RE: SUBMISSIONS TO THE LOKICHAR-LAMU CRUDE OIL PIPELINE ENVIRONMENTAL IMPACT ASSESSMENT STUDY REPORT

COMMENTS ON THE LAMU LOKICHAR CRUDE OIL PIPELINE ESIA STUDY REPORT

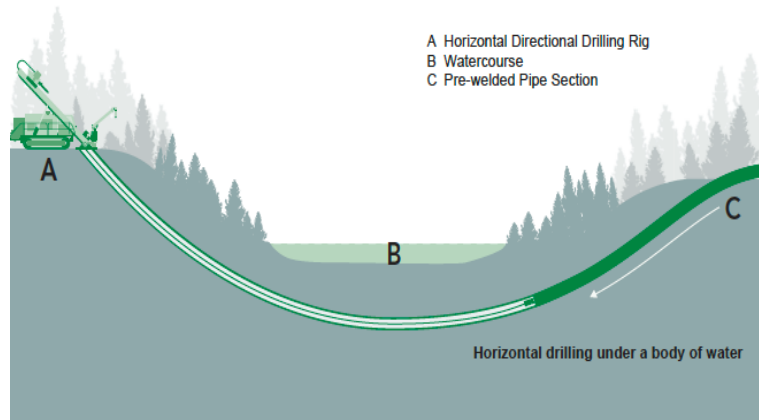
Section 6.4	The ESIA fails to consider measures for preventing impacts to rivers	<p><i>The construction of a crude oil pipeline could disturb river beds of important rivers such as the Ewaso Ngiro River which the pipeline crosses</i></p> <p>The manner in which the construction of a pipeline crosses an important river determines the magnitude and duration of adverse impacts to such river. Importantly, <i>such impacts can be avoided entirely by the use of horizontal directional drilling (HDD)</i> in which a pipeline is laid beneath a river without disturbing the river itself.</p> <p>See the following material and illustration:</p> <p>“Trenchless techniques require limited or no in-stream construction and so cause little to no disturbance to the watercourse bed and banks. The most common type of trenchless crossing is a Horizontal Directional Drill (HDD). HDD can be used to avoid congested or environmentally sensitive areas such as large or sensitive water bodies.”¹²</p>	We recommend that the project proponent provide more information on the use of horizontal directional drilling (HDD), as an alternative to the open cut method, and outline how this method can be used for preventing the disturbance of the beds of these rivers, including creation of heavy sediment loads.
